Access Compliance Report

Public Rights-of-Way

(Curb Ramps)

Intersection ID: 4063	Main Street: MOUNTAIN_PINE_DR	Cross Street: SHADY_REACH_LN	Location: W
ADA ID: 3813FC99DC7A	Ramp Type: Perp	Initial Pass/Fail: Fail	Overall Compliance: No
Severity Score: 31.25			
Codes/Mitigation Info/Possible Solution		Field Measurements/Component Compliance

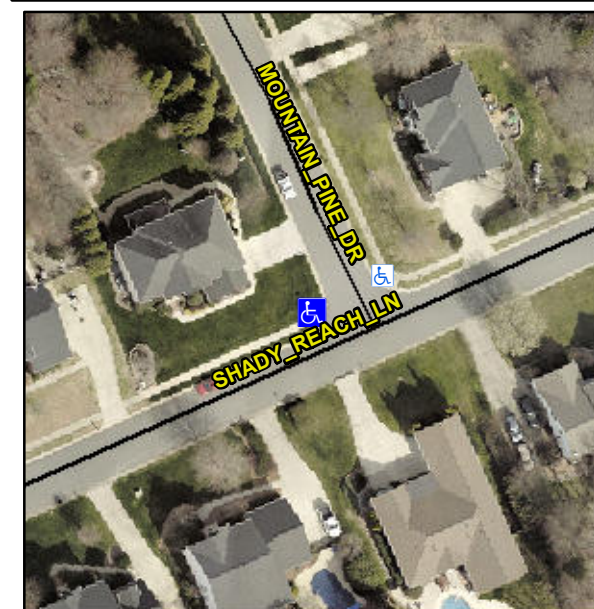
Not Found, R304.5.1, R304.2.2, R304.5.3

Compliance	Description	Data	Compliance	Description	Data
N/A	Ramp Length (in)	45.5	No	Ramp Slope (%)	8.4
No	Ramp Width (in)	33.5	No	Ramp XSlope (%)	4.2
N/A	Flare Type LT	N/A	N/A	Flare Type RT	N/A
N/A	Flare Slope LT (%)	N/A	N/A	Flare Slope RT (%)	N/A
N/A	Flare Traversable LT?	N/A	N/A	Flare Traversable RT?	N/A
N/A	Landing Length (in)	N/A	N/A	DWS Provided?	N/A
N/A	Landing Width (in)	N/A	N/A	DWS Contrast?	N/A
N/A	Landing Slope (%)	N/A	N/A	DWS Length (in)	N/A
N/A	Landing X Slope (%)	N/A	N/A	DWS Full Width?	N/A
N/A	Landing Curb? (Y/N)	N/A	N/A	DWS Offset (in)	N/A
N/A	Shared Landing?	N/A			
N/A	Gutter Ponding?	N/A	N/A	Gutter Slope (%)	N/A
N/A	Gutter Lip Ht (in)	N/A	N/A	Gutter X Slope (%)	N/A
N/A	Painted X Walk1?	No	N/A	Painted X Walk2?	N/A
	X Walk 1 Direction	To E		X Walk 2 Direction	N/A
N/A	X Walk 1 Width (in)	N/A	N/A	X Walk 2 Width (in)	N/A
	X Walk 1 Slope (%)	6.3		X Walk 2 Slope (%)	N/A
	X Walk 1 X Slope (%)	0.2		X Walk 2 X Slope (%)	N/A

Remove & Replace Entire Ramp.
